# Staff Report

**Project Name:** Coffee Shop and Workforce Development Center  
**Case Number:** COA24-0001  
**Application Types:** Certificate of Appropriateness (COA)  
**Location:** 2506 W Alamo Ave

Request for a Certificate of Appropriateness to allow for a coffee shop and workforce development center site improvements.

Figure 4: Proposed designs on north elevation for ADA ramps, 2506 W. Alamo Ave.

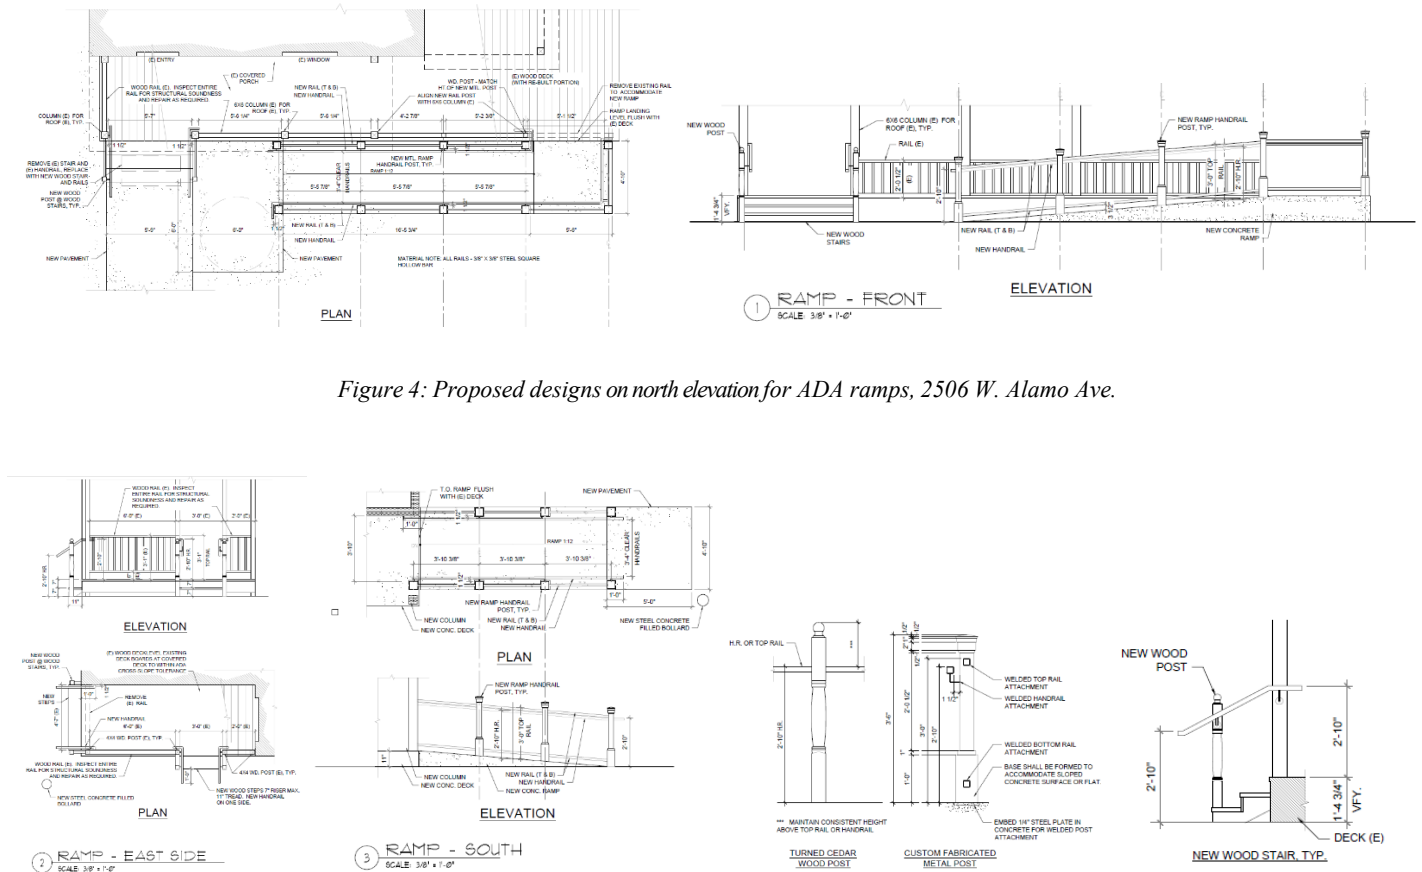
In the elevations referenced above, the proposals show the proposed exterior improvements and additions to the existing structure. The majority of the improvements are related to providing ADA accessibility throughout the site to enable its use as a workforce development center and coffee shop. The proposed ramp on the front façade of the structure would minimally obscure the historic railing portion on the eastern edge of the existing front porch. This proposed ramp would require altering the non-historic deck and railing towards the west.

Figure 9: Proposed designs on south elevation highlighted, 2506 W. Alamo Ave.

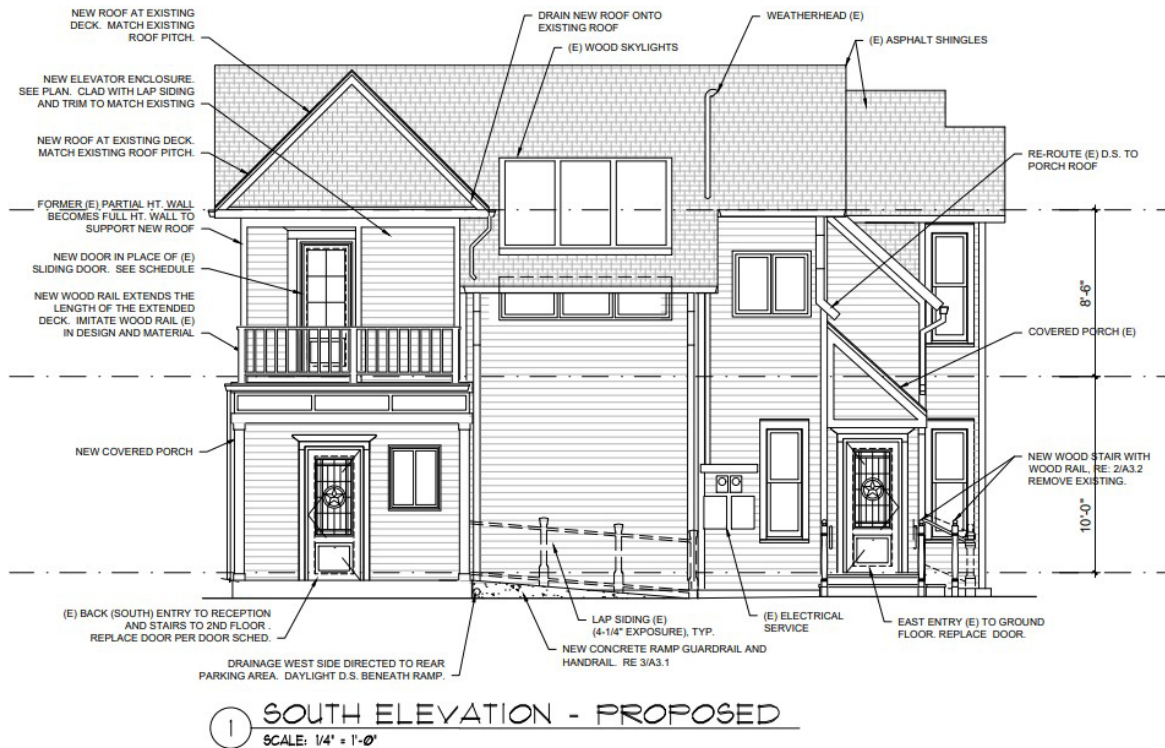
- i. 3.27 Preserve the original roof form of a historic structure.
  - 1. *Proposal includes changes to the roof form of the rear of the structure, which will not be easily visible from the street and has been modified in the past. The angles of the roof line reference the existing home and do not add inappropriate architectural elements to the structure.*
